Technical Note TN7.1

3rd October 2008

800 series PSU exchange: UMEC to XP

Old-type PSU: UMEC UPO653S-01

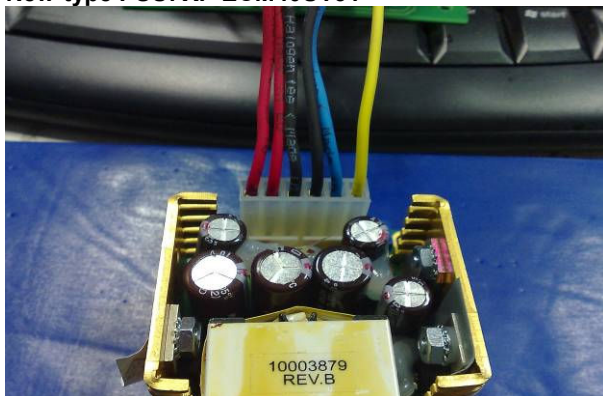
Yellow (12V), Red, Red (5V), Black, Black (0V), Blue (-12V).

The connecting wires must be re-arranged into the order shown in the following picture.

New-type PSU: XP ECM40UT31

Red, Red (5V), Black, Black (0V), Blue (-12V), Yellow (12V).

The power supply is factory set at 5.2 Volts. Check the voltage after installation. If it is not 5.2V, the output should be adjusted using the trimmer located adjacent to the 6-way header.

Switch PCB modification

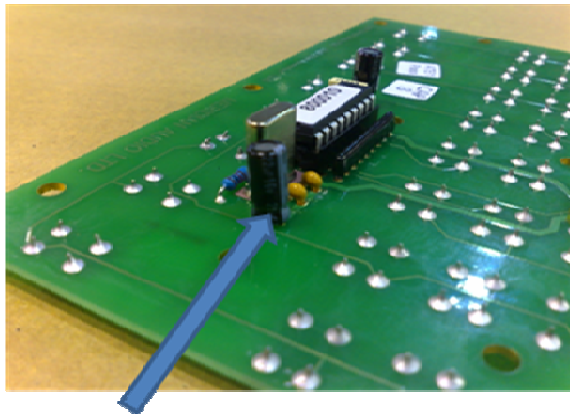
When fitted with the new-type PSU, 800 series products require a modification to the Switch PCB within the front-fascia assembly. This involves removing a capacitor and fitting a three-pin “watchdog” IC.

Remove capacitor C3

Add watchdog IC, DS1813 (Meridian part number D81813)

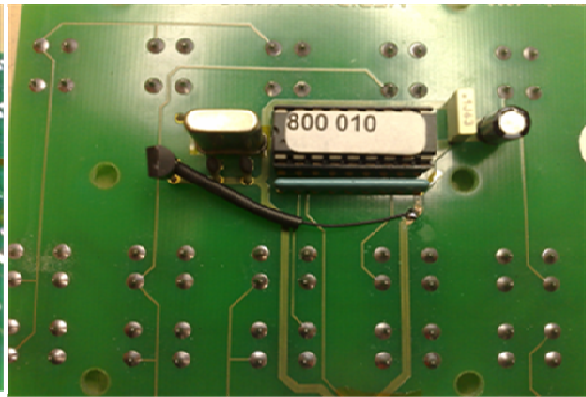
Solder the two outer pins of the IC into the footprint left by the removal of the capacitor. The centre pin (VCC) of the IC should be connected to the 5V track on the PCB. To do this, scrape away a portion of solder-resist from the 5V track and use a flying lead as shown in the picture above.

Note: Failure to carry out this modification may result in the front-panel keys locking up after a power cycle.
